WATER LICENCE INSPECTION FORM

Licensee Representative									
Bonito Capital Corps -									
Licence No. / Expiry				Representa	tive's Title				
2BM-ULU1520				-					
Land / Other Authorizations				Land / Othe	er Authoriz	ations

Report #2015-KIT021-EP Page **1** of **9**

2BM-ULU1520 REPORT OF JULY 15 2015 INSPECTION

Date	Camera	Inspector		Authorization
July 15, 2015	SONY DSC-HX50V	Eva F	Paul	2BM-ULU1520
Photo Log # 1		Location (NAD 83	DD MM SS.SS)	
Photo DSC03429		N66 54 29.8	W110 57 49.3

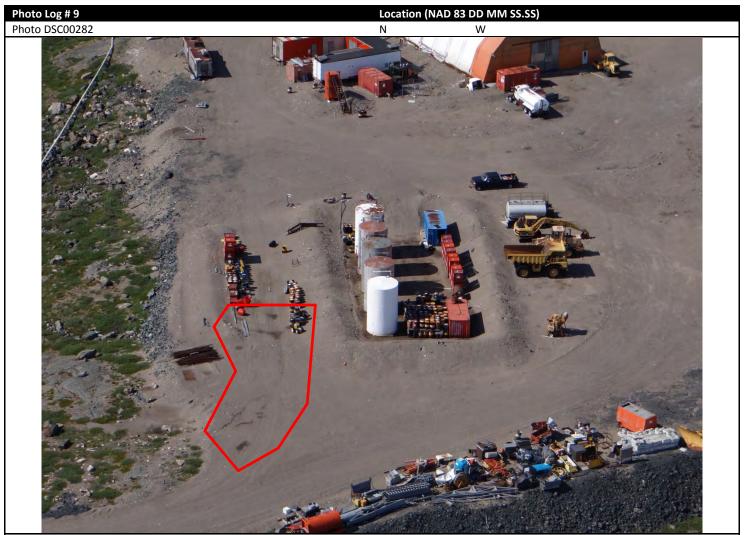
- 1. Waste and waste storage areas remain unidentified and waste (particularly potentially-hazardous waste) is not being stored according to the Waste Management Plan. Unmarked barrels of unidentifiable waste (with staining underneath) remain to the east of the helipad [Photos 1 and 2] and at the mine storage pad [Photo 3]. Three barrels containing a salt-like substance were noted beside the road to the west of the main site [N66 54 26.3 W110 58 21.3][Photo 4]. All barrels containing hazardous, or unknown (potentially hazardous) waste need to be moved into containment, at a minimum, until proper disposal. A comparison from 2014 to 2015 does show that LMI has moved some barrels into the main tank farm berm and/or the fuel storage pad/apron [Photos 5 and 6].

Description: Barrels of unknown waste and staining on the ground found east of the heli-pad.

- 5. All hazardous (and unknown) waste is to be moved into SOUND secondary containment that meets the definition of 'secondary containment' in the current licence 2BM-ULU1520. This is to be completed by June 30, 2016.

- 5. All hazardous (and unknown) waste is to be moved into SOUND secondary containment that meets the definition of 'secondary containment' in the current licence 2BM-ULU1520. This is to be completed by June 30, 2016. We anticipate to have this work will completed by June 20, 2016.
